Battle Creek Historic District Commission

Staff Report

Subject: The petition filed by Historic Adventist Village for the issuance of a Determination of Appropriateness to install fencing along portions of their property to comply with zoning and historic district commission requirements.

Location of proposed boardwalk and fencing

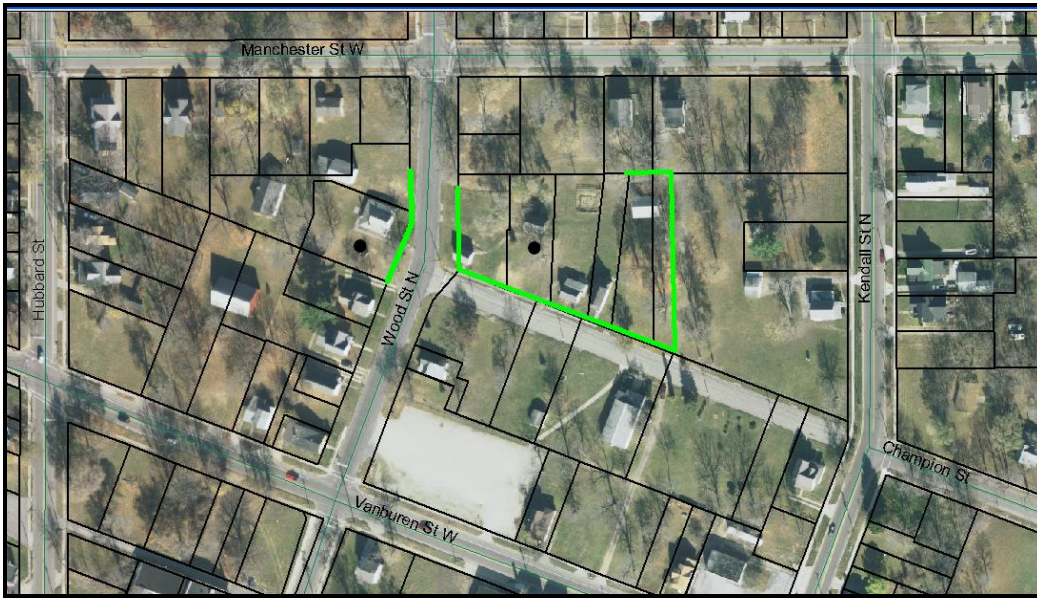
The proposed project includes site improvement additions of a fencing along property portions of N. Wood Street and Champion Street that will comply with zoning requirements and meets HDC approval requirements for the issuance of a Certificate of Approval on the properties shown on the aerial photo immediately following this paragraph depicted in green. The petitioner has provided a drawing of the various fence designs and the specific location of where each type of proposed fencing will be located. Additionally, we are expecting someone from the Adventist Village to be at the meeting to answer any questions you might have relating to the project.
